Access Compliance Report

Public Rights-of-Way

(Curb Ramps)

Intersection ID: 10198	Main Street: FONTANA_AV	Cross Street: REMBERT_CT	Location: SE
ADA ID: BCF011B6C30F	Ramp Type: Perp	Initial Pass/Fail: Fail	Overall Compliance: No
Codes/Mitigation Info/Possible Solution		Field Measurements/Component Compliance

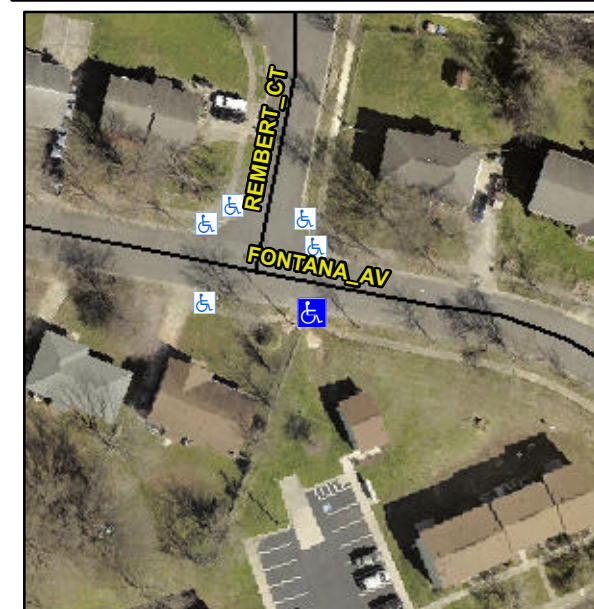
Not Found, R304.2.2

Compliance	Description	Data	Compliance	Description	Data
N/A	Ramp Length (in)	48.0	No	Ramp Slope (%)	10.6
Yes	Ramp Width (in)	48.0	Yes	Ramp XSlope (%)	4.4
N/A	Flare Type LT	N/A	N/A	Flare Type RT	N/A
N/A	Flare Slope LT (%)	N/A	N/A	Flare Slope RT (%)	N/A
N/A	Flare Traversable LT?	N/A	N/A	Flare Traversable RT?	N/A
N/A	Landing Length (in)	N/A	N/A	DWS Provided?	N/A
N/A	Landing Width (in)	N/A	N/A	DWS Contrast?	N/A
N/A	Landing Slope (%)	N/A	N/A	DWS Length (in)	N/A
N/A	Landing X Slope (%)	N/A	N/A	DWS Full Width?	N/A
N/A	Landing Curb? (Y/N)	N/A	N/A	DWS Offset (in)	N/A
N/A	Shared Landing?	N/A			
N/A	Gutter Ponding?	N/A	N/A	Gutter Slope (%)	N/A
N/A	Gutter Lip Ht (in)	N/A	N/A	Gutter X Slope (%)	N/A
N/A	Painted X Walk1?	No	N/A	Painted X Walk2?	N/A
	X Walk 1 Direction	To N		X Walk 2 Direction	N/A
N/A	X Walk 1 Width (in)	N/A	N/A	X Walk 2 Width (in)	N/A
	X Walk 1 Slope (%)	2.6		X Walk 2 Slope (%)	N/A
	X Walk 1 X Slope (%)	5.0		X Walk 2 X Slope (%)	N/A

Remove & Replace Entire Ramp.
